ADDENDUM # 002

RE: Cherokee Nation Entertainment
Tahlequah Casino

- Item 1** Addendum #002 Summary of Changes
- Item 2** Revised Plumbing Drawings
- Item 3** Revised ITS101 and ITS102

Description of Revisions Narrative

SHEET NUMBER:
PU1.5
PLUMBING
ENLARGED
UNDERSLAB PLAN -
NORTH

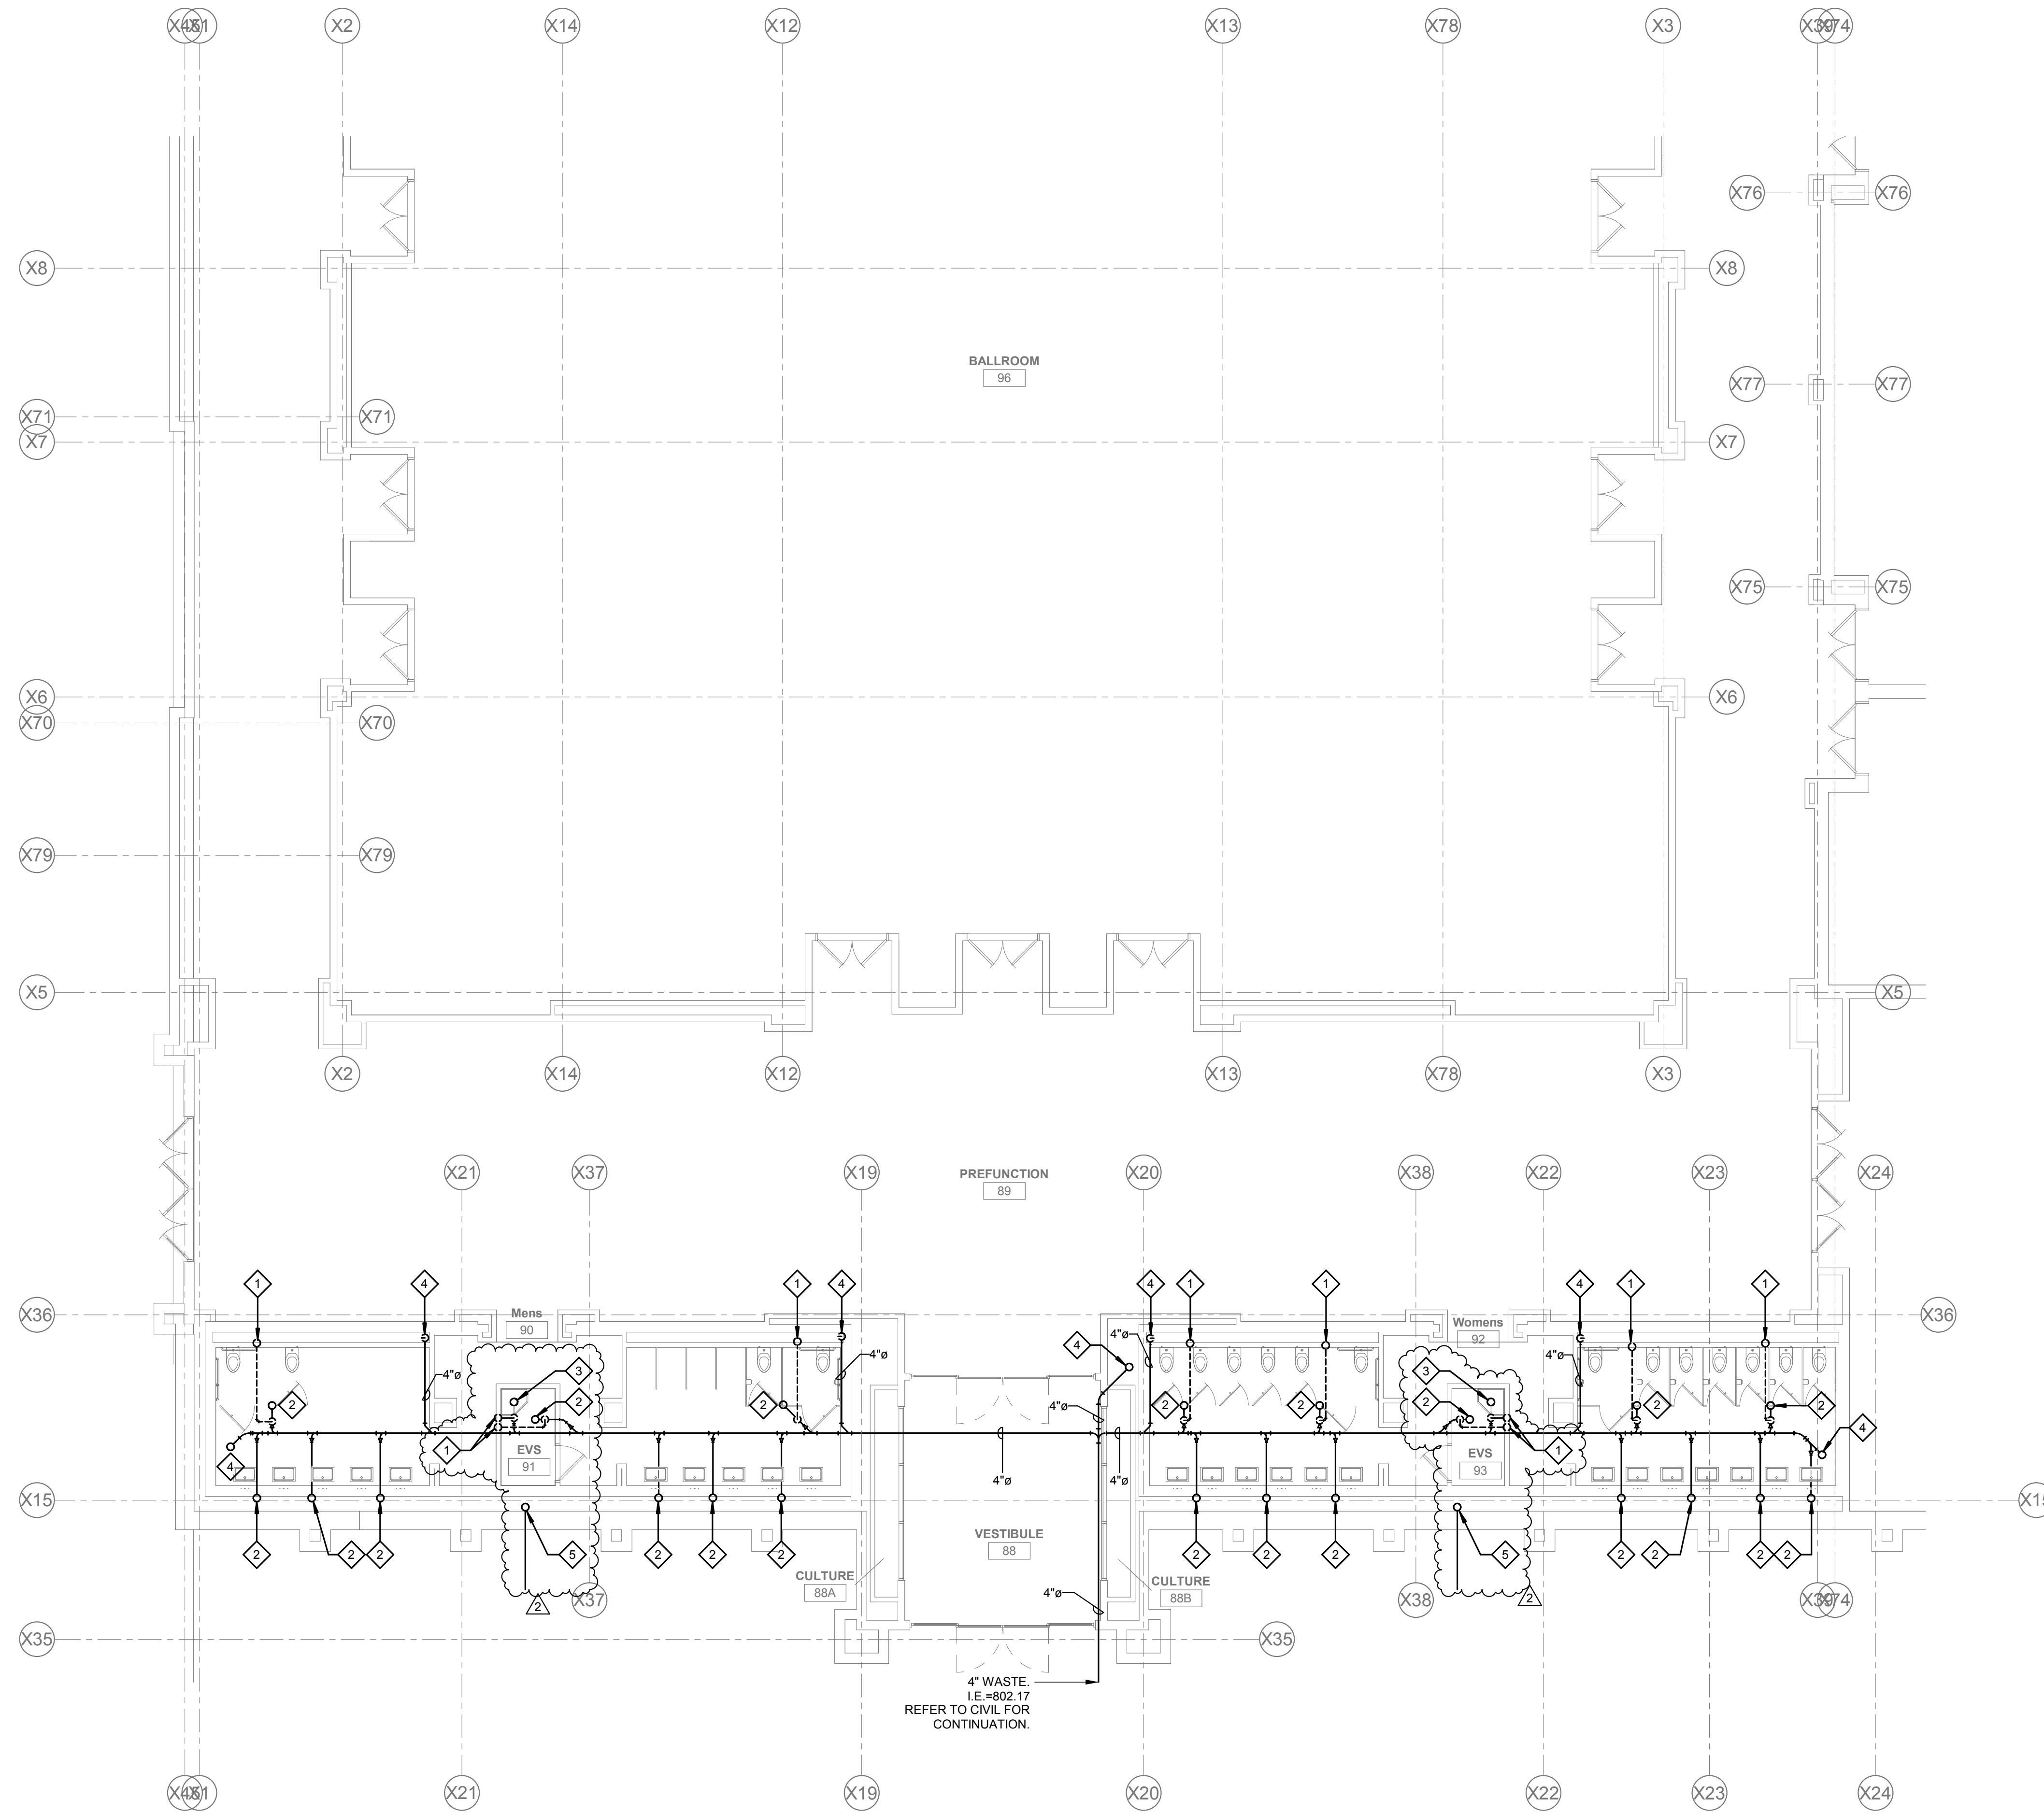
<u>Sheets</u>	<u>Description</u>
PU1.1	Added (1) 8" Storm drain penetration / floor drain / mop sink to EVS Storage 33. Added floor drain / mop sink EVS 21. Moved waste and vent lines into architectural wall shift in Mens 11 & Womens 13. Added floor drain / sink to Fire Riser 34.
PU1.2	Added carbonated beverage/liquor lines in Bar 17. Extend waste/vent lines to hand sinks in Kitchen 75 & 79. Added mop sink & floor drain to EVS 79B and mop sink to 79A. Relocated vent lines to consolidated column in Bar 85. Added carbonated beverage lines to Bar 85.
PU1.3	Added (2) 8" storm drain penetrations.
PU1.4	Extend waste/vent lines to hand sinks in Banquet Food Preparation 98. Added (3) 8" storm drain penetrations.
PU1.5	Added (2) 4" storm drain penetrations. Added mop sink and floor drain to EVS 91 & 93.
